**NOTICE OF A REGULAR
PLANNING COMMISSION MEETING
October 7, 2026, at 7:00 PM**

Agenda Item: PLAN26-0011 Site Plan Application - Minor Amendment Orchards Phase 7

The Orchards Phase 7: Building 53

THE ORCHARDS AT HOMESTEAD
PHASE 7 & 8 - BUILDING 59
VINYARD UTAH

Lot 6, Phase 11
Site Plan

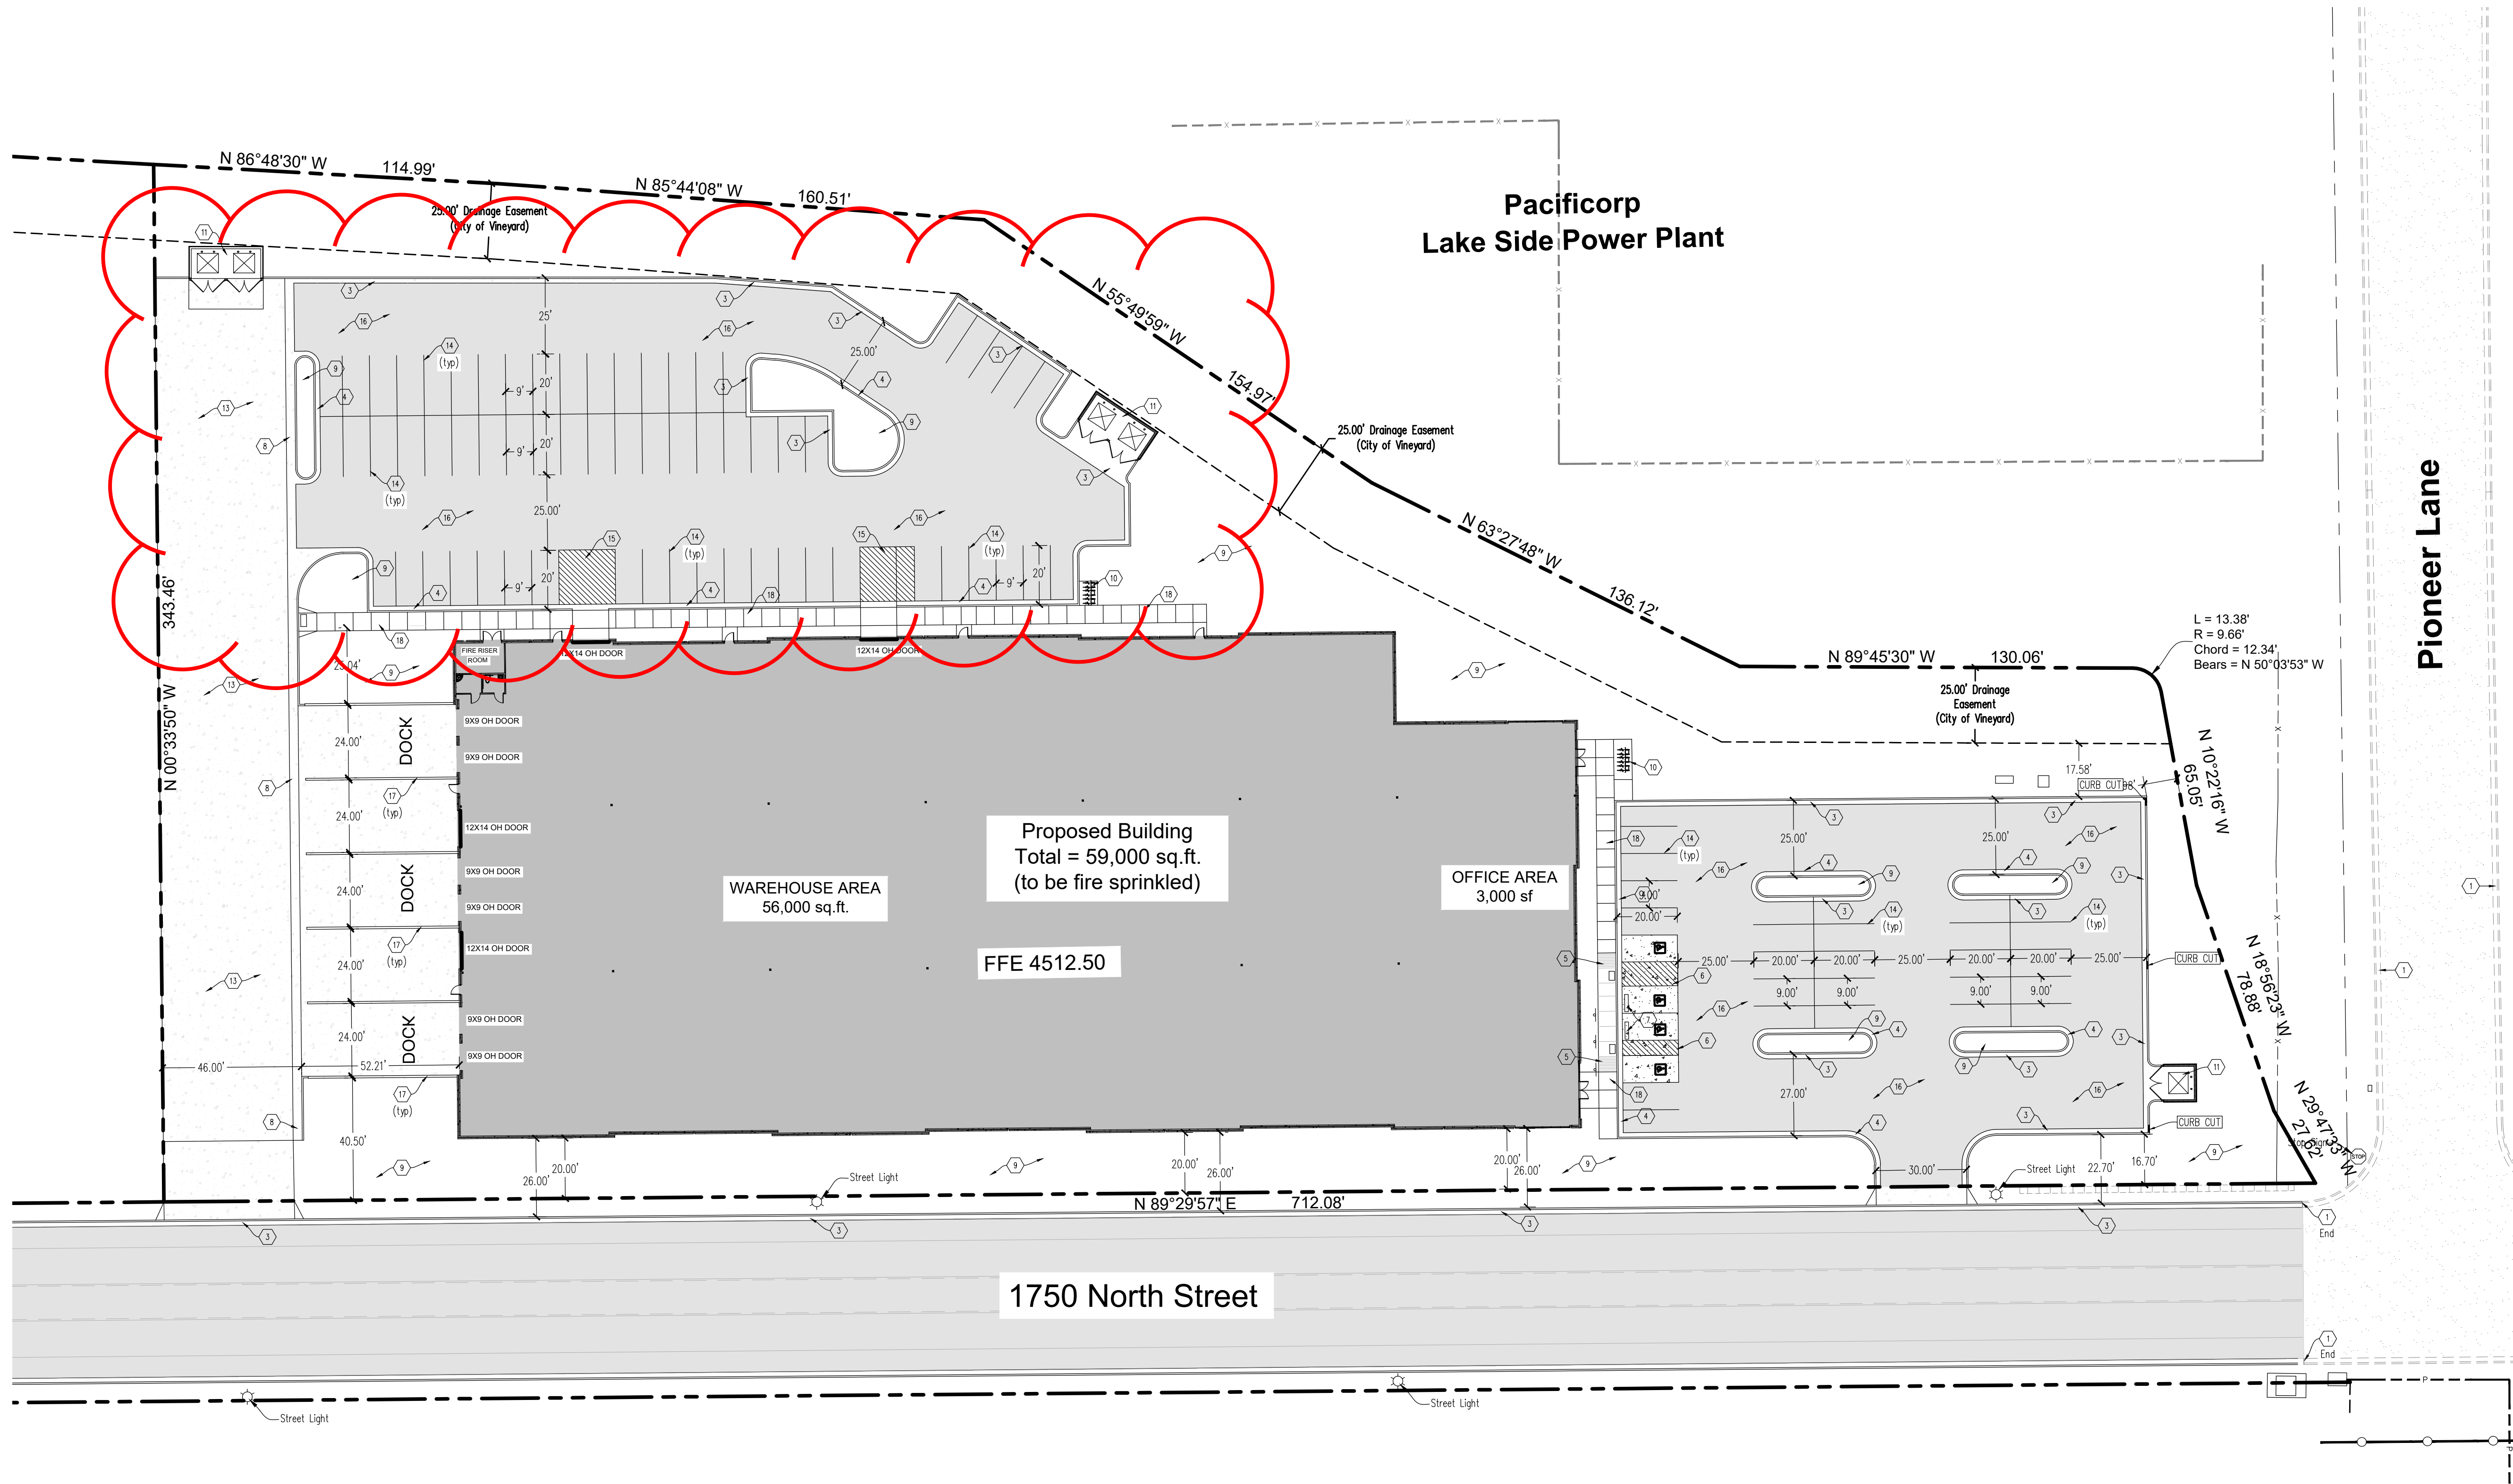
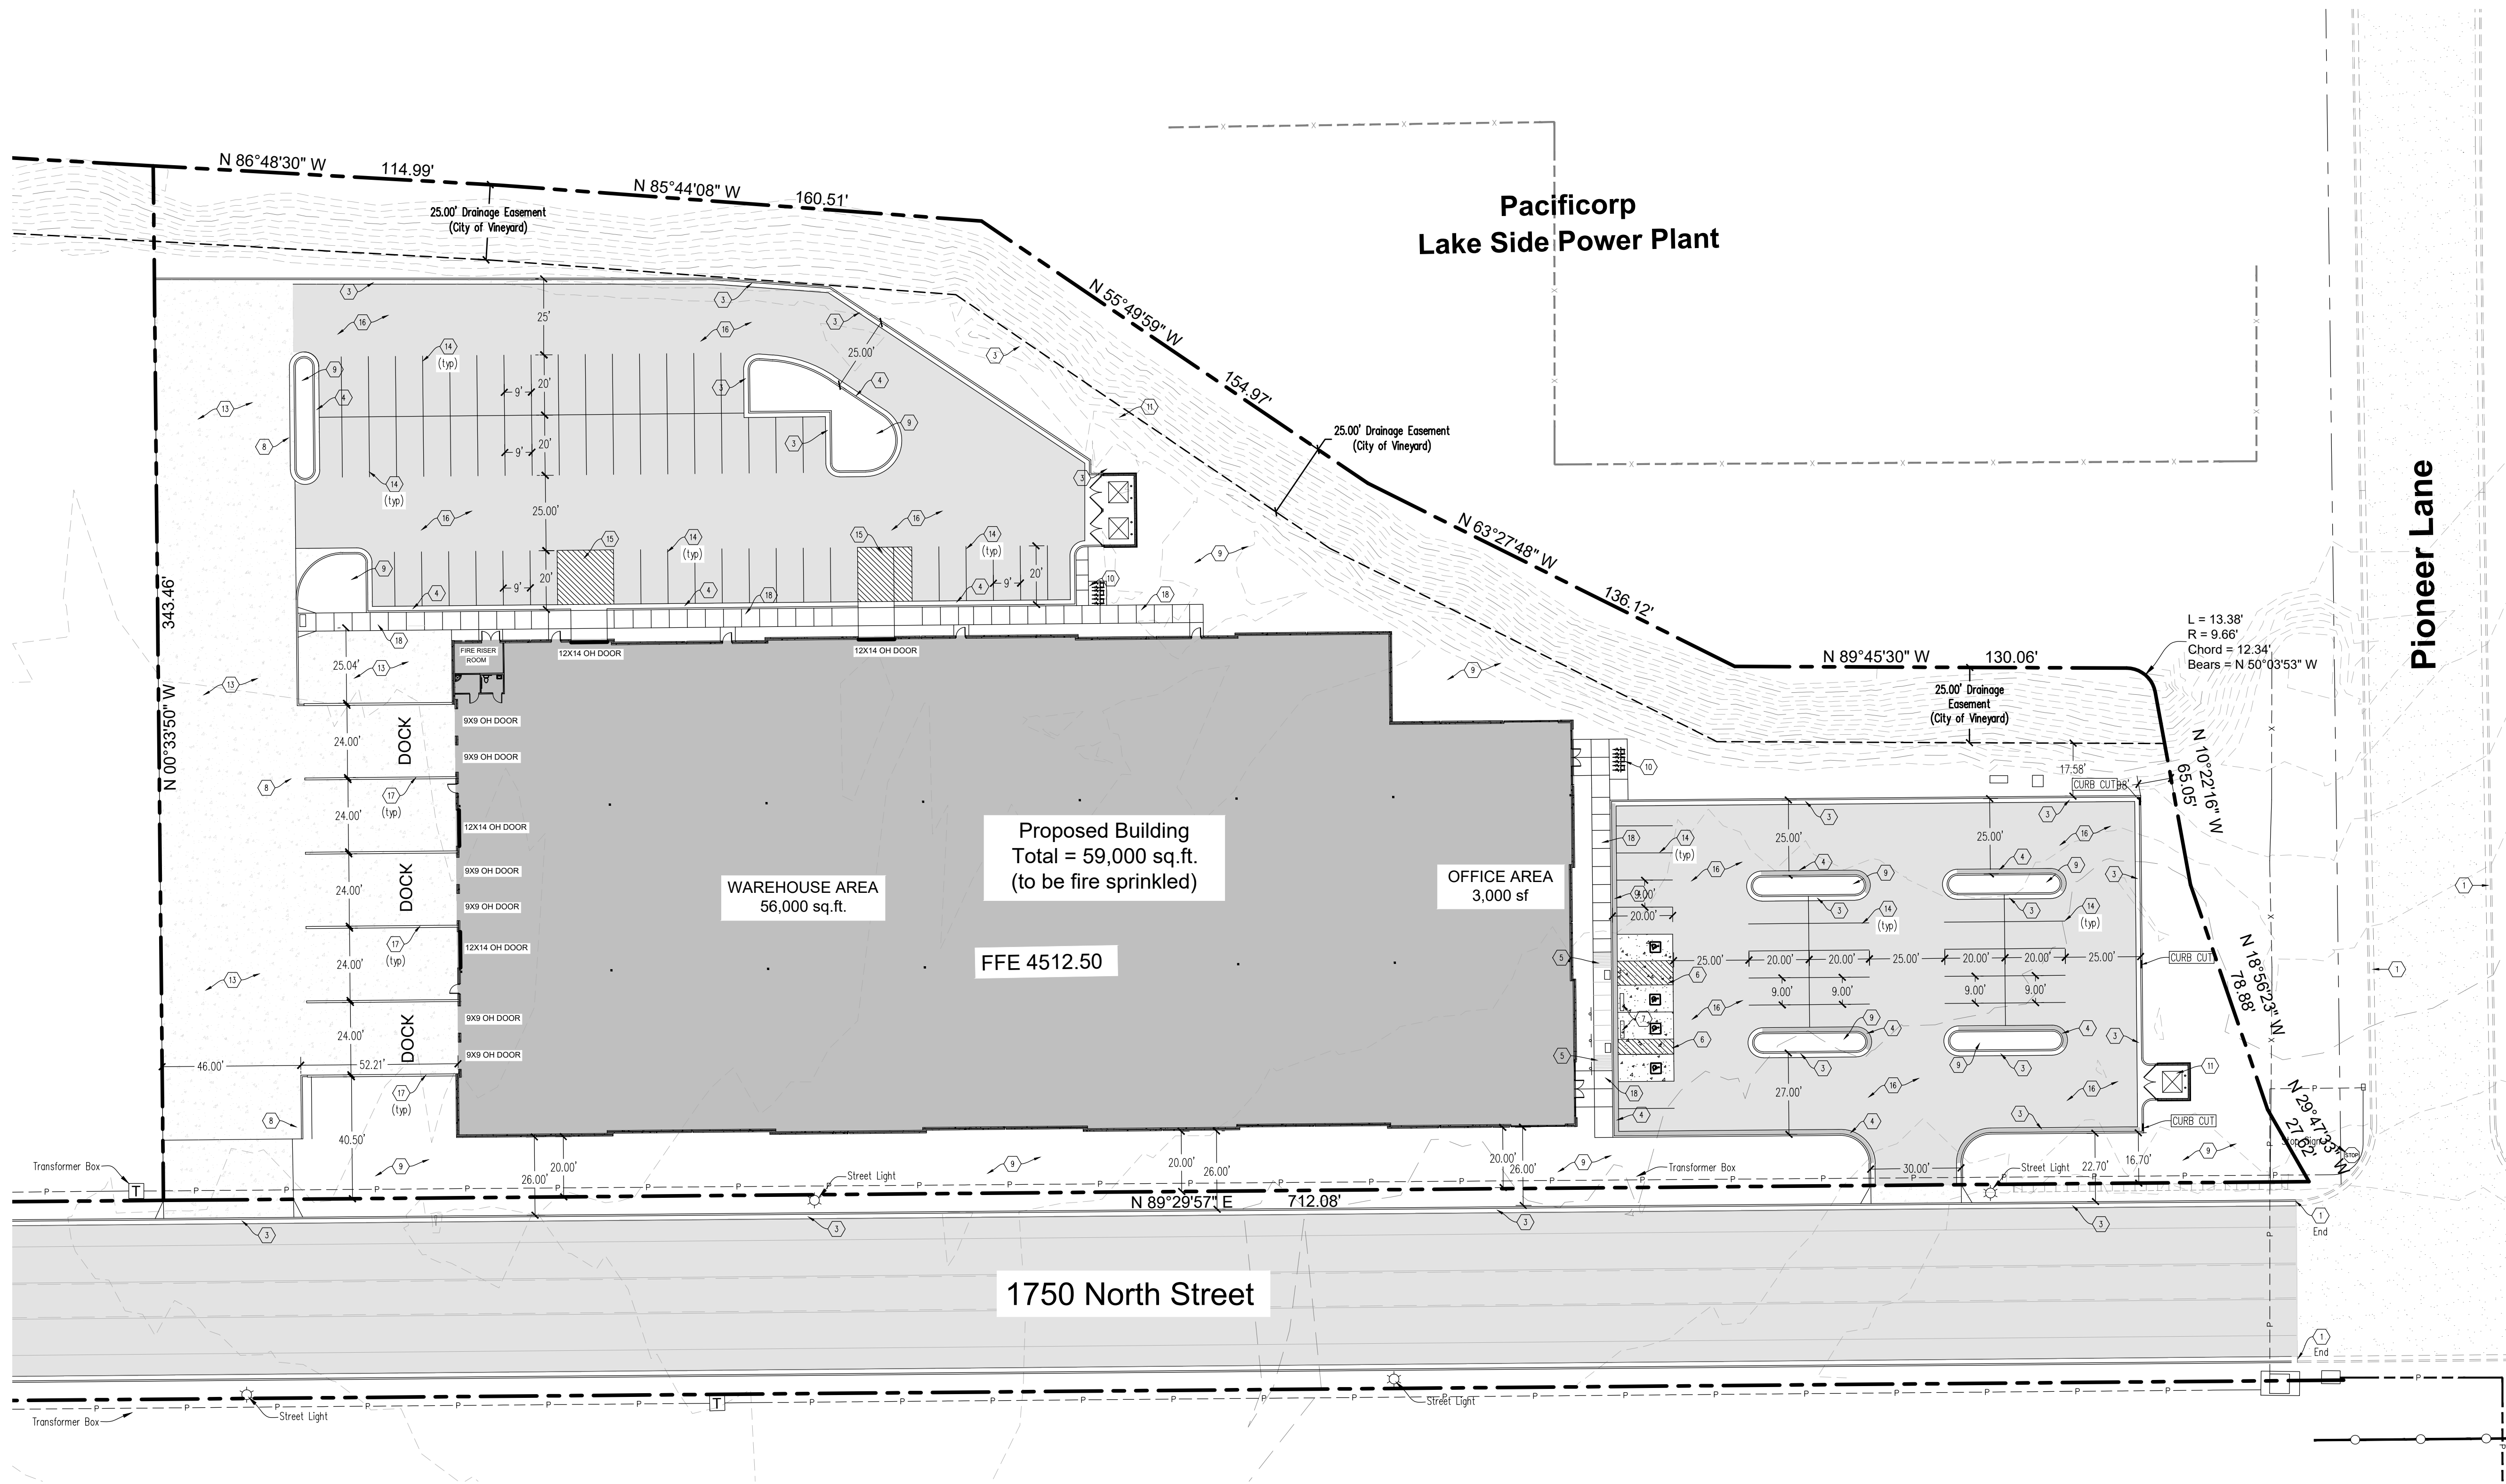
The applicant, Vineyard Properties of Utah, is requesting a site plan amendment to relocate the previously approved dumpster enclosure, as shown in the attached plans. No changes to the building or parking layout are proposed. The site requires 85 parking spaces and provides 88 spaces; therefore, the proposed amendment will not affect compliance with the City's parking requirements.
